Ch 9, Sec 5, [5.5.1]

We would like to confirm a way to apply the requirement of this sub-paragraph to a structural member shown in the attachment.

Figure : Variable cross-section stiffener

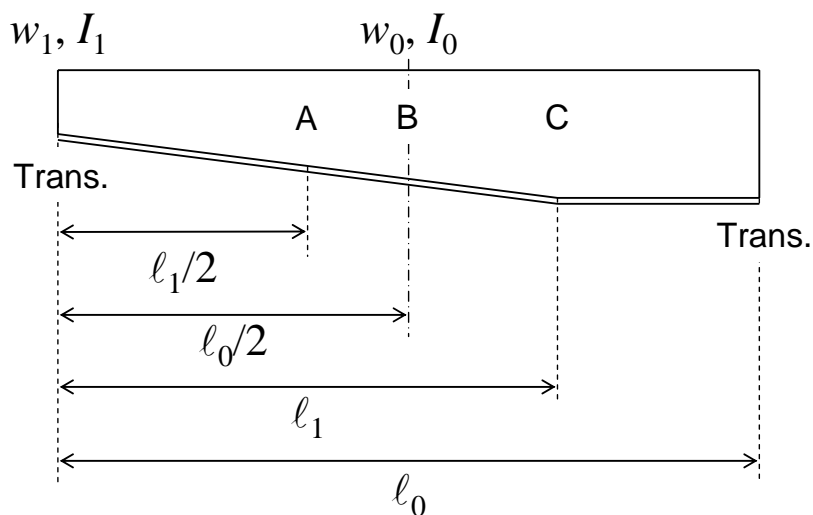
(1) Which position, A, B or C, shown in Figure, is to be selected to calculate  $w_0$  and  $I_0$ ?

We consider that position B is suitable for this requirement. Please confirm.

(2) Which position, A, B, C or else, is to be considered when the requirement of net section modulus of ordinary stiffeners,  $w$ , is applied?

We consider that position A is appropriate for this requirement. Please confirm.
